TV Products Service Bulletin

291R1 No.

Subject: Circuit Change-Reference Number R854, R859

On The "E" Board

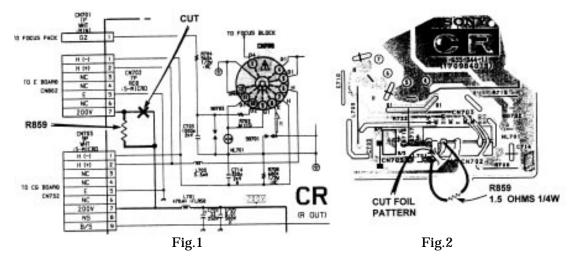
Circuit Change -1:

- R859 was not mounted on E board originally. Therefore, you are required to cut the foil pattern on the CR Board between CN702/pin 7, and CN703/pin 7, then mount R859 as illustrated in Fig 1 & 2.
- **b.** Replace R854 on the "E" Board with the value below.
- **C.** Replace C808 even if it seems OK. Same value and part number as original.

REF	FORMER		NEW	
	DESCRIPTION	PART NUMBER	DESCRIPTION	PART NUMBER
R854	1 OHM, 1/4W	1-249-381-11	1 OHM, 1/2W	1-260-292-11
R859	NONE	NONE	0.47 OHM, 1/2W	1-260-288-11
C808	10MF/160V	1-107-636-11	10MF/160V	1-107-636-11
